CLYDACH VALE ALN SCHOOL
STAGE 3 ACOUSTIC DESIGN REPORT

Project no. P1308
Report ref. 26CC05-FOR-10-XX-T-OJ-0003
Date 27-09-2024
Revision P01

SOUND INSULATION MARK-UP

Drawing Title: GENERAL ARRANGEMENT PLAN - LEVEL 00

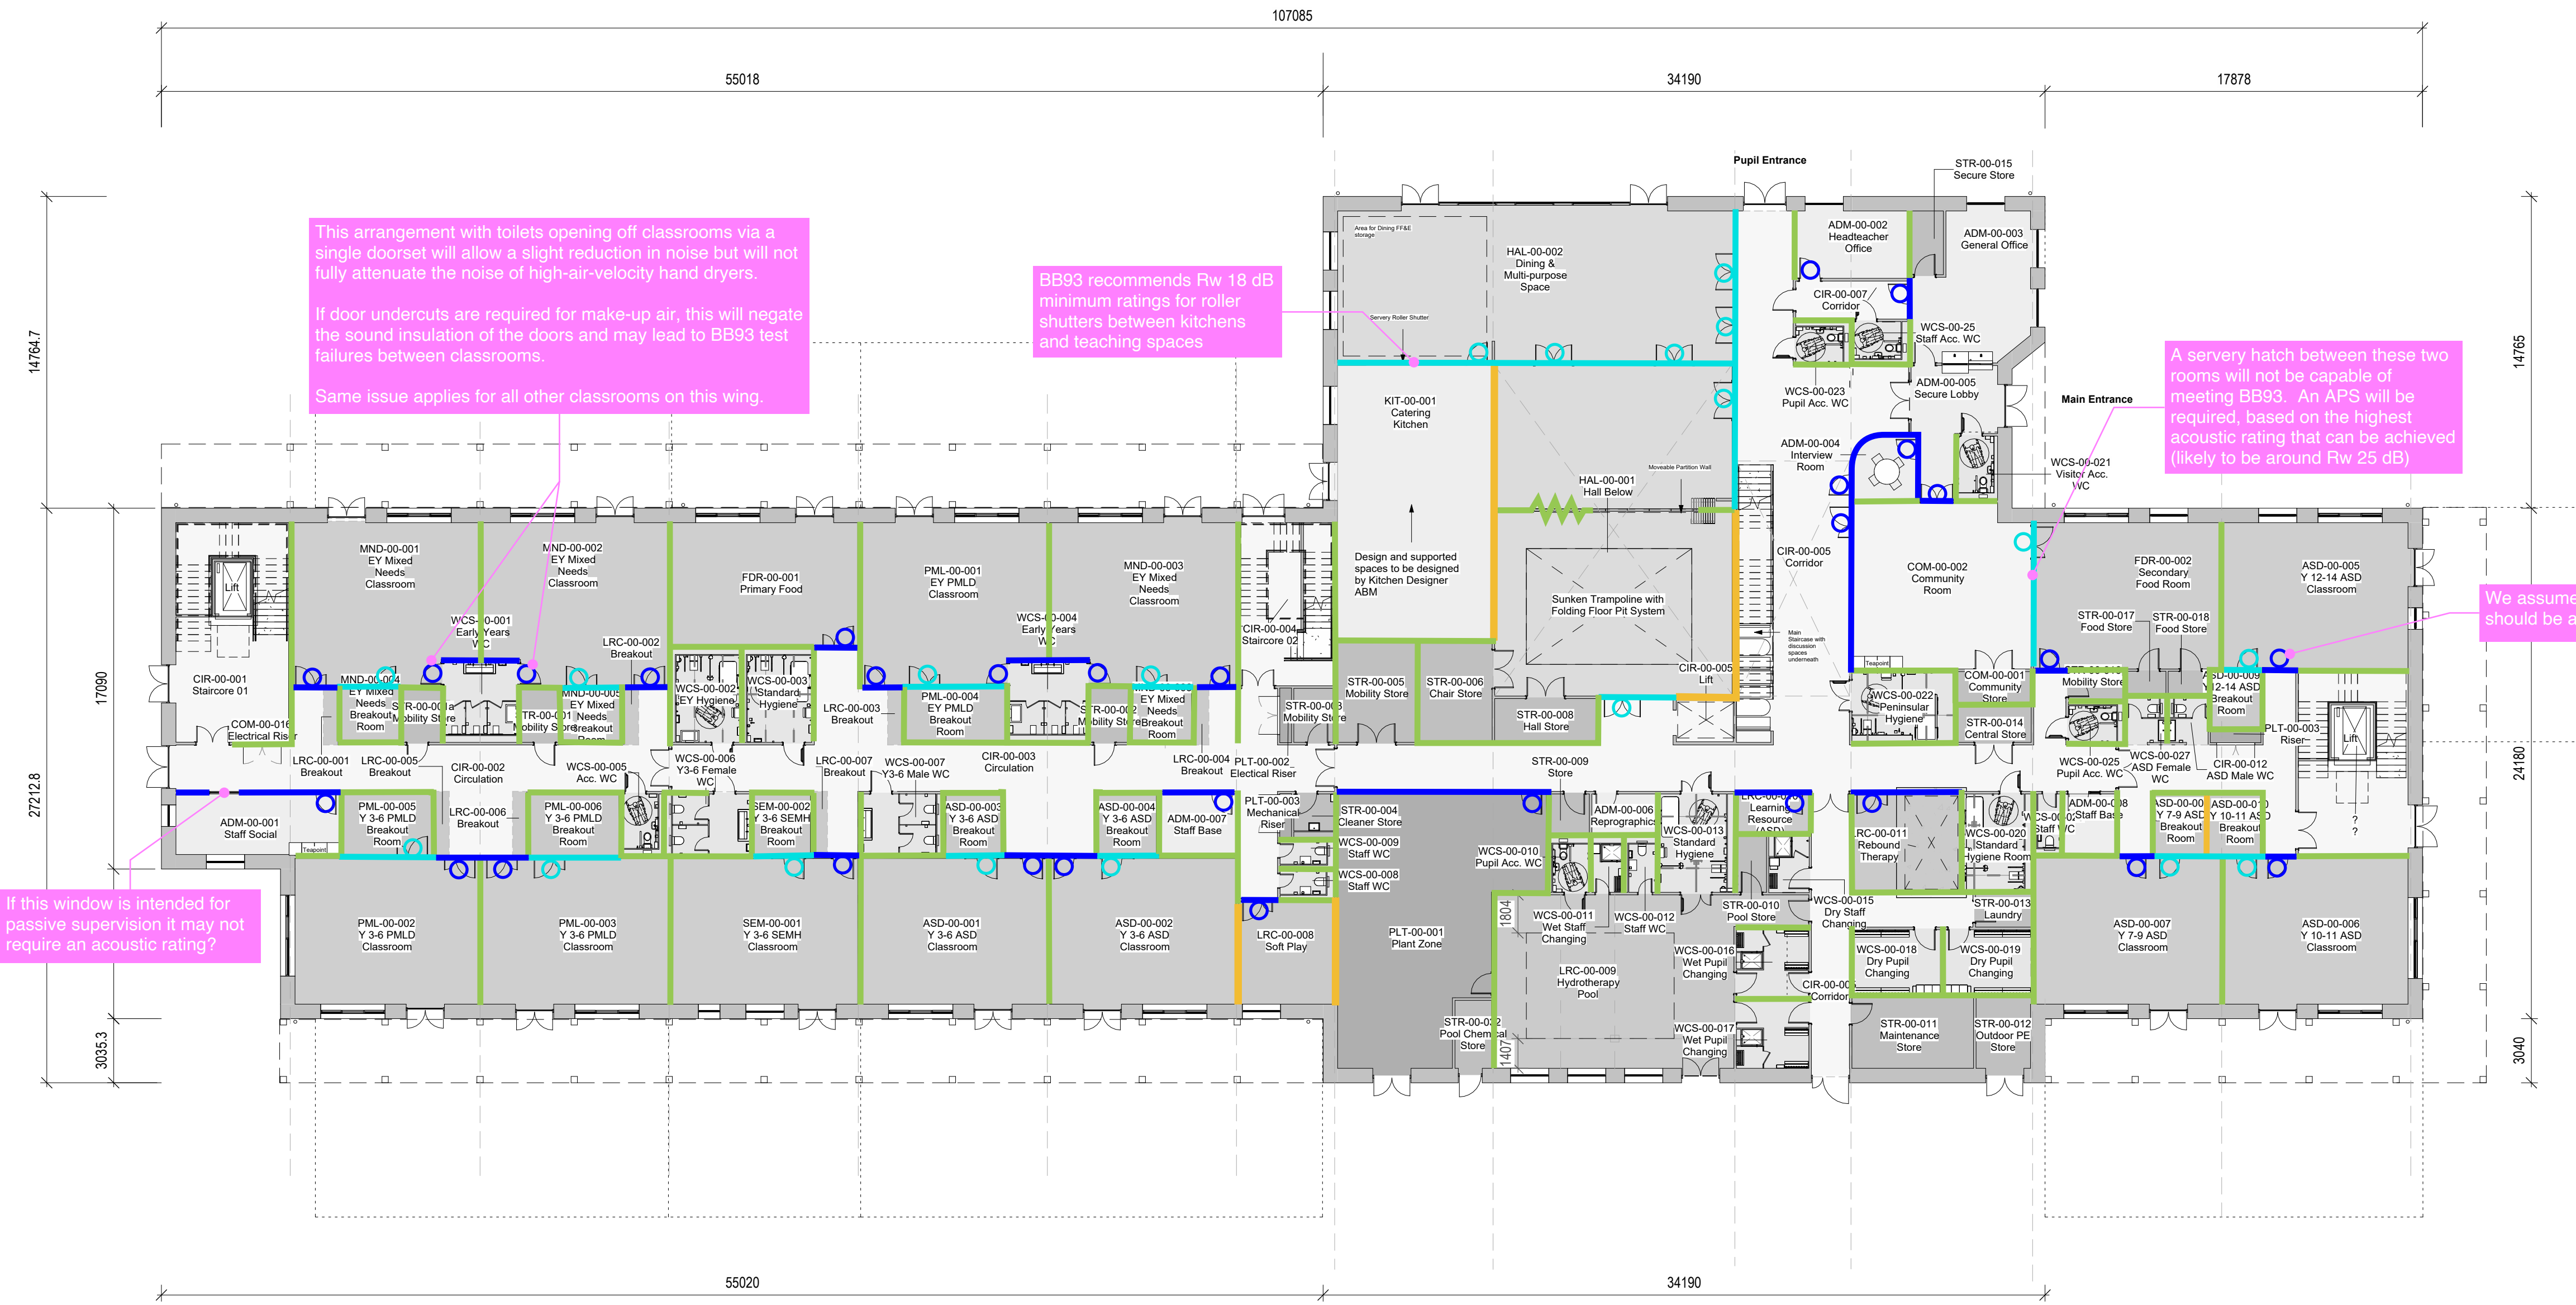
This arrangement with toilets opening off classrooms via a single doorset will allow a slight reduction in noise but will not fully attenuate the noise of high-air-velocity hand dryers. If door undercuts are required for make-up air, this will negate the sound insulation of the doors and may lead to BB93 test failures between classrooms. Same issue applies for all other classrooms on this wing.

BB93 recommends Rw 18 dB minimum ratings for roller shutters between kitchens and teaching spaces

A servery hatch between these two rooms will not be capable of meeting BB93. An APS will be required, based on the highest acoustic rating that can be achieved (likely to be around Rw 25 dB)

We assume there should be a door here.

If this window is intended for passive supervision it may not require an acoustic rating?
